Ocean Apparels Nangtong Tongfeng Co. Ltd

DS-2, 1st Floor, Road 02, Export Processing Zone, Chittagong

21 June 2014

Uncontrolled Storage Loads

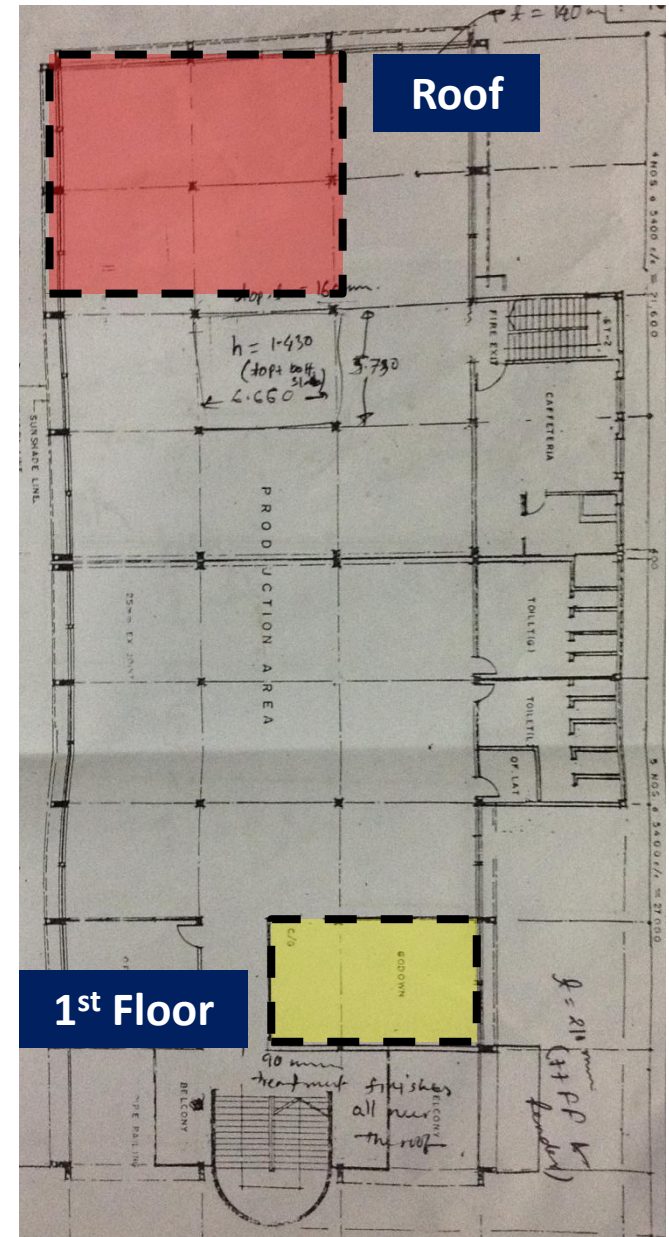
Uncontrolled loading observed on roof and first floor.

Unregulated storage observed on roof top. Potential for increased storage in dry season.

Uncontrolled / unrestricted loading observed on first floor.

**Movement joint has been
stitched across at roof level**

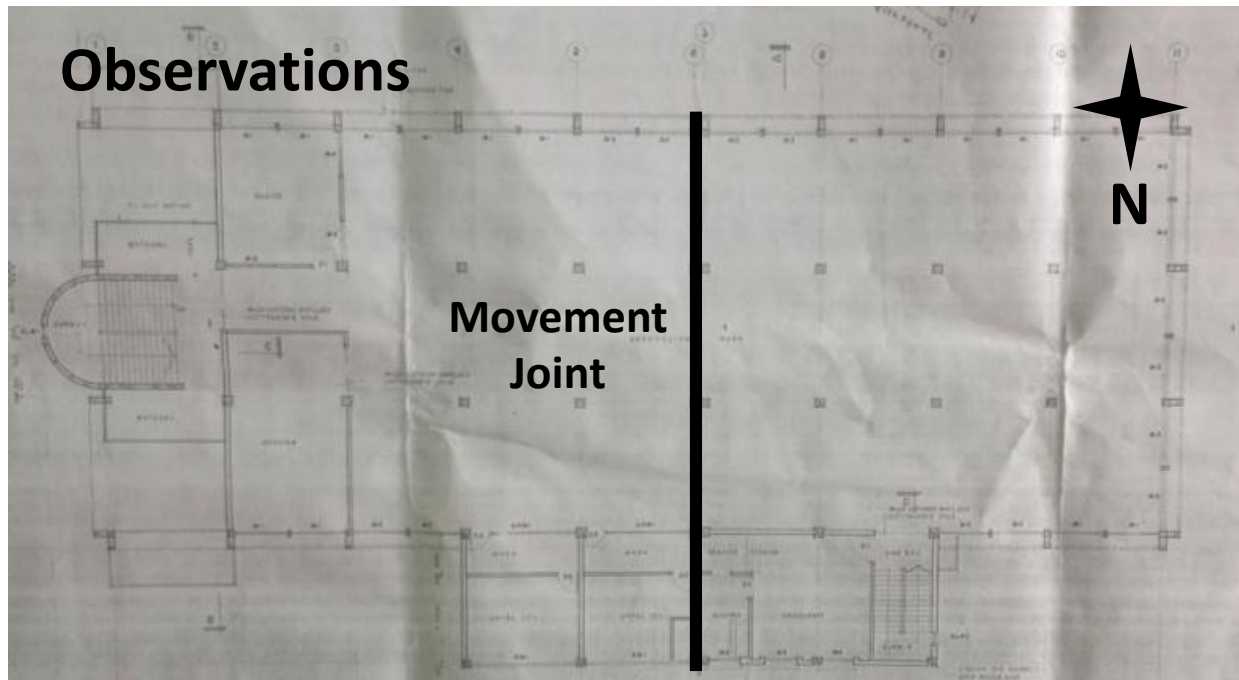
Movement joint exist at centre of structure, spanning in the North to South direction.

Expansion joint has been covered with concrete at roof level, inhibiting any expansion.

Joint has been plastered over at lower levels with water ingress due to lack of appropriate water proofing at roof level.

Drawing Inconsistencies

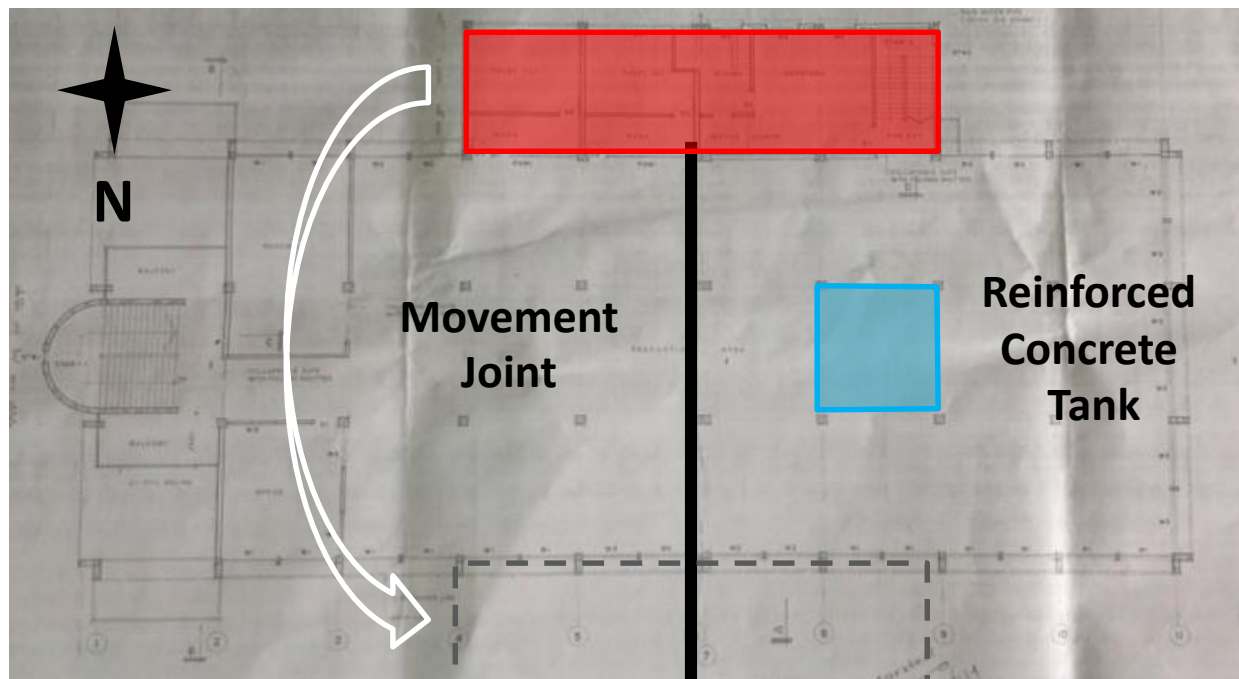
The structural drawings do not match the current arrangement and orientation of the building, and there are inaccuracies in the drawings.

Drawing provided consist of a plan for adjacent building which is a mirror floor plan of surveyed structure.

Additional RC Water Tank observed on roof of structure with no documentation to show structural design of element.

6	Inconsistencies between presented documentation and observed structure	Building Engineer to assess column capacity in location of the RC water tank located on the roof	6-months
7	Inconsistencies between presented documentation and observed structure	Loading plans to be created for all floors (including roof), taking into account the additional load from water storage that was not present on the as-built drawings	6-months
